PLANNING, ZONING, & BUILDING DEPARTMENT
PZ&B Staff Combination Memorandum: Architectural Commission and Town Council

SUBJECT: ARC-24-0023 (ZON-24-0010) 515 N LAKE WAY (COMBO)

MEETING: DECEMBER 20, 2024, ARCOM
JANUARY 15, 2025, TC

Currently proposed site plan (drawing rotated with north on its side for representation)

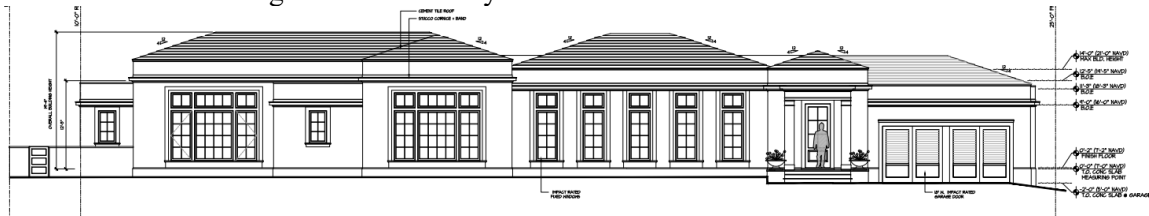
The applicant has indicated the depth is deficient for this non-conforming lot due to the address, angle of vision and current front door location. ARCOM members discussed the relationship of this new structure to that immediately east. The proposed site and floor plans are still similar to the previous versions but the visual impact on the south elevation has improved by relocating the garage doors to the west. Additionally, the relocation of the entry to the west elevation allows the structure to read as less of an accessory building.

Previous

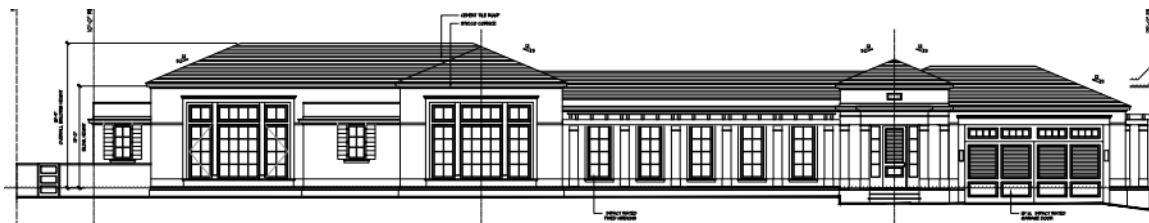
The proposed house is similar in massing to the one existing on site. The exterior has a smooth stucco finish painted creme, punctuated with black metal multi-lite windows and doors. The house features mainly hip roofs with some minor flat roof areas. The hip roofs are surfaced with flat gray concrete tiles. The single door front entry is now accessed from the west.

(graphic of site plan rotated 90° for visual reading ease)

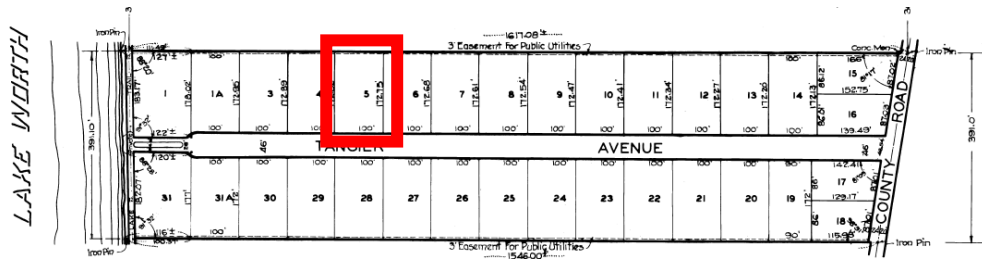
The Angle of vision zoning regulation is a tool intended to complement the setback requirements by ensuring that the mass of the building is ‘pushed back’ from the street, at least visually, by creating this additional step back regulation. This regulation is mostly applied to the north or south facade face of the residences due to the long linear layout of the Island, having mostly east-west streets developed with residences. When applied to corner properties, or those with more unique configurations, such as the subject property—compliance is more challenging. In this specific instance, the width of the lot along N Lake Way measures over 172’ in length making it very challenging to comply with the wide aperture of the angle of vision; yet the code specifically requires such; *In the case of corner lots or through lots with frontage on the following primary north-south roadways, the building angle of vision shall be applied only to the frontage along the designated primary north-south roadway: North Ocean Boulevard; South Ocean Boulevard; North County Road; South County Road; and North Lake Way.*
